REMARKS/ARGUMENTS

AMENDMENTS TO THE DRAWINGS:

Figure 3.1 - Z2002A Software Block Diagram

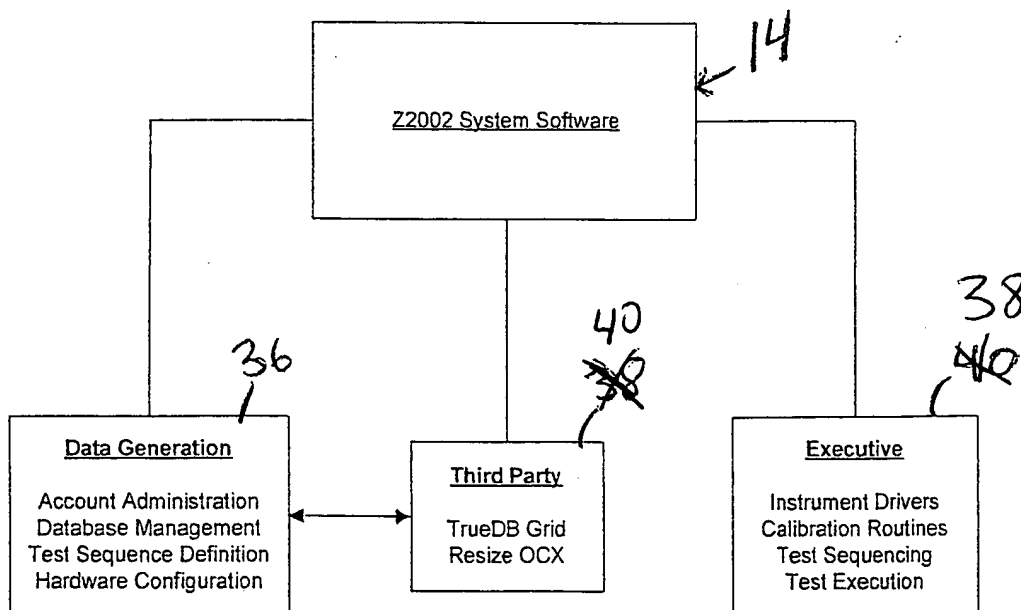
In response to the objections to the specification and drawings, proposed revised Figs. 3.1 and 3.2 are submitted herewith in which the executive software is labeled consistently with reference numeral 38 and the third party software is labeled consistently with reference numeral 40.

The attached sheets of drawings include changes to Fig. 3.1 and 3.2. The sheet which includes Figs. 1 and 3.1 replaces the original sheet including Figs. 1 and 3.1 and the sheet including Fig. 3.2 replaces the original sheet including Fig. 3.2. In Fig. 3.1, the designation of the executive software is changed from “40” to “38” and the designation of the third party software is changed from “38” to “40”. In Fig. 3.2, the designation of the executive software is changed from “40” to “38”.
